Center for Auto Safety White Paper on Concerns With
Chrysler Recall of the Jeep Grand Cherokee and Liberty
Presented to NHTSA July 1, 2013

Chrysler has responded to the National Highway Traffic Safety Administration's request that it recall the Jeep Grand Cherokee and Liberty that have fuel tanks installed behind the rear axle for defects in their fuel systems with several specious arguments

Figure 1. A comparison with the subject Jeeps and other vehicles that Chrysler had purported to show had worse rear impact fire performance but which had no deaths due to fire in FARS in rear impacts where there was a fire in the listed vehicle.

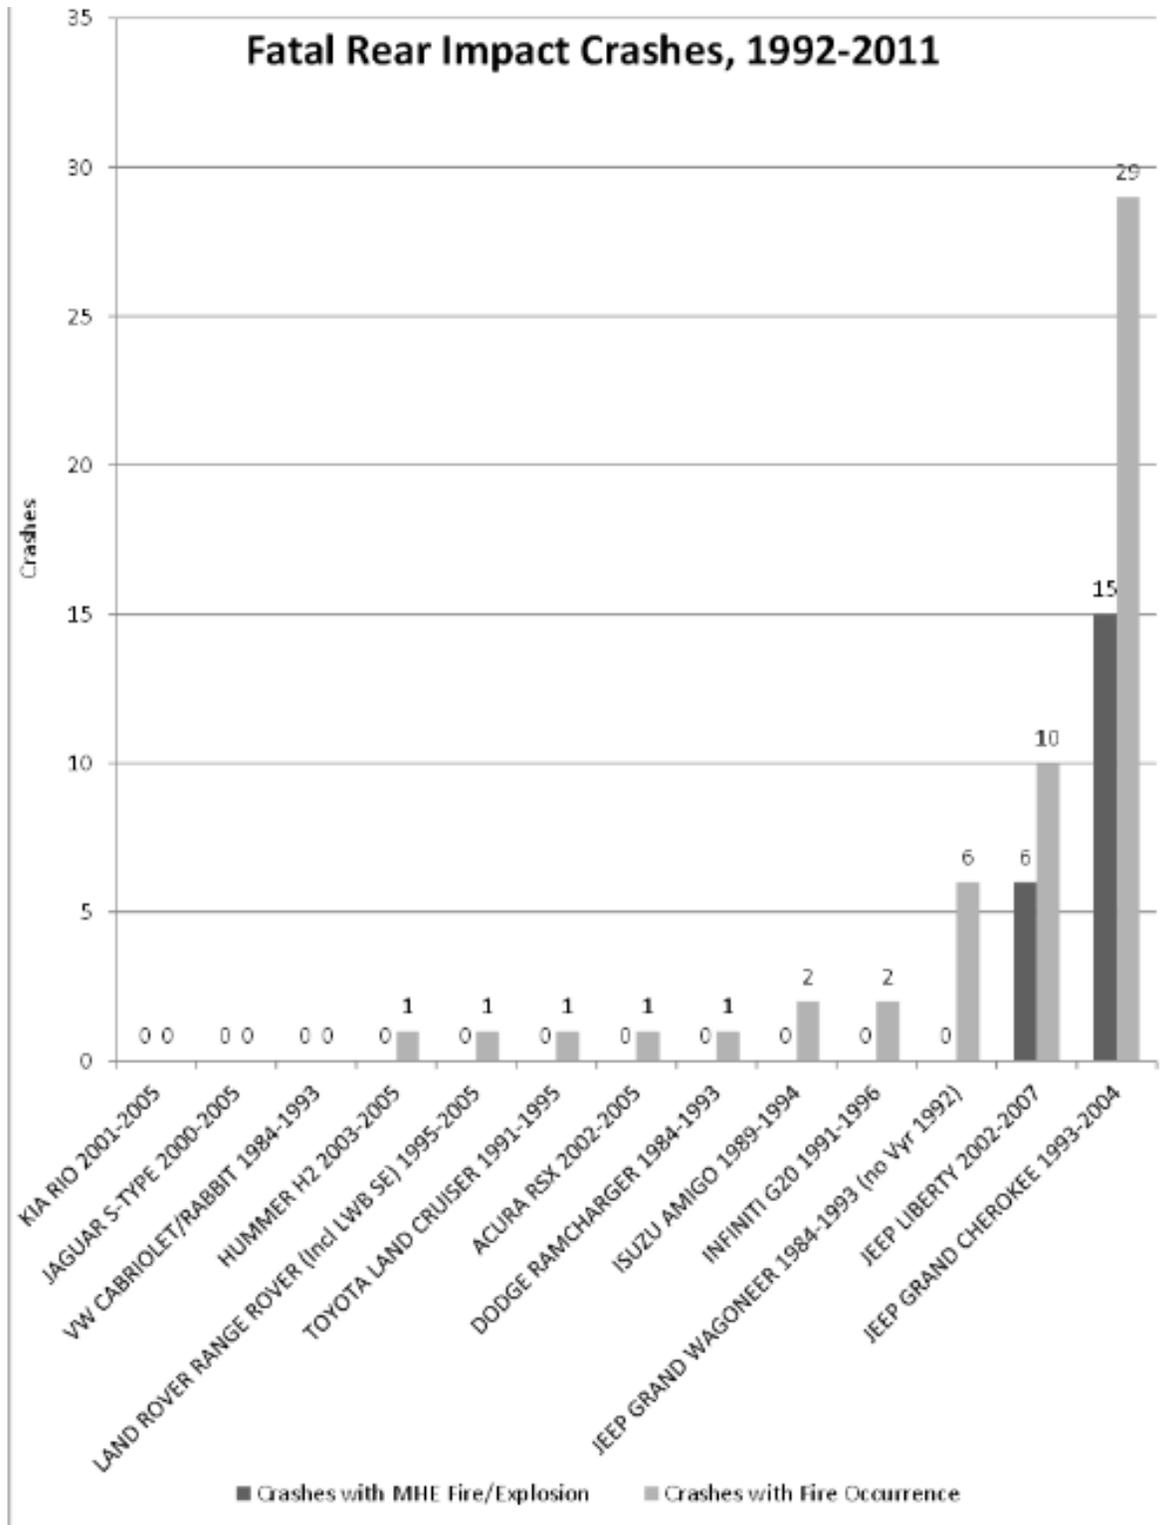
Chrysler has produced various tables that claim to show that Jeep Grand Cherokee and Liberty models have crash fire rates that are no worse than most other vehicles. We looked at the FARS files from 1992-2011 for the 31 vehicles where some or all of the vehicles were made in 1993 or later and found quite a different picture. Figure 1 shows that the Grand Cherokee and Liberty had 21 crashes (15 for the former and 6 for the latter) where fire was listed as the most harmful even and 39 crashes where there was fire (29 and 10, respectively). By comparison, eleven of the Chrysler so-called comparable vehicles did not have any crashes where fire was the most harmful event. Thirteen more vehicles had only one or two rear impact fire crashes. Only the 1994-2004 Ford Mustang has a comparable Fire-MHE fire rate. ⁵ What Chrysler was doing was counting trauma deaths along with fire deaths knowing that compact vehicles like the 2300# Toyota MR2 would always have a higher fatality rate due to trauma versus fire compared to the 4100# Grand Cherokee.

Chrysler included (Appendix D) an extensive discussion of confidence intervals in an attempt to show that one could not draw firm conclusions from the data where there were relatively small total numbers of relevant crashes. However, it is easy to see that the discrepancy between the performance of the subject Jeeps and other vehicles in Figure 1 is quite strongly indicative of a genuinely different crash experience between them and other vehicles in this chart. Similarly, the difference in the FARS data on Jeeps with fuel tanks mounted behind and ahead of the rear axle shows quite statistically different performance in the field. Chrysler does not discuss this appendix in the text of its June 18 letter because Appendix D shows that one cannot rely on the data behind its misleading comparison of various other makes and models to the Jeep Grand Cherokee and Liberty because the sample size and number of fatal fire crashes in such other models is so small.

Figure 2. A chart submitted by Chrysler as part of their early response to NHTSA's investigation. Note that while Chrysler combined sisters and clones in most cases, it did not combine the very small volume Honda Passport with its sister Isuzu Rodeo.

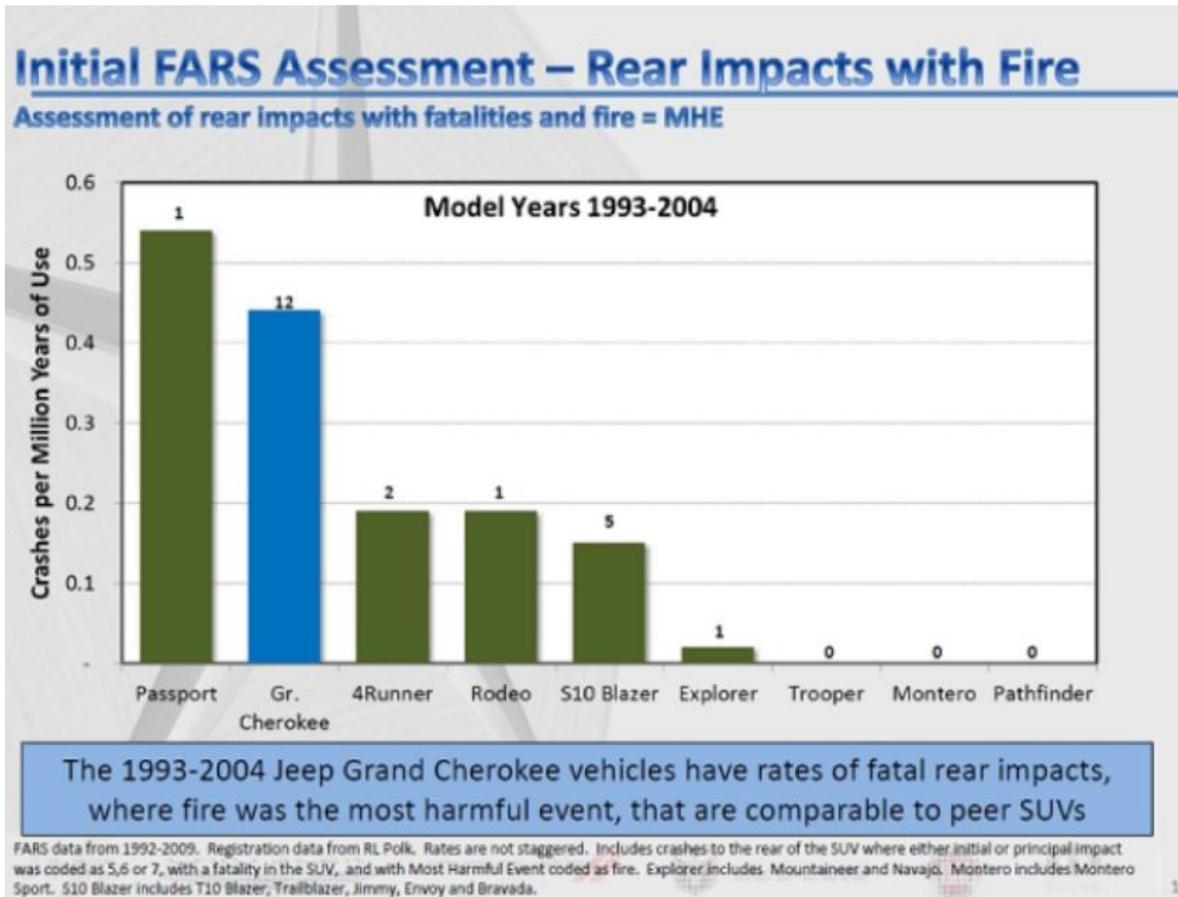
Looking at Chrysler's own chart which normalized these results (Figure 2) for the Grand Cherokee – with 12 cases where fire was the most harmful fatal event – had 4.4 per hundred thousand vehicle-years of use. The Honda Passport, which is a sister of the Isuzu Rodeo and should have been included with them, had only one crash on this chart, but when we looked at this case it was not even a rear impact but rather a frontal with a Chevrolet Tahoe.⁶ (Also, because of the small population of these vehicles, there were a

very small number of vehicle years of use). None of the other vehicles in this chart had a rate greater than 2 per hundred thousand vehicle years of use.
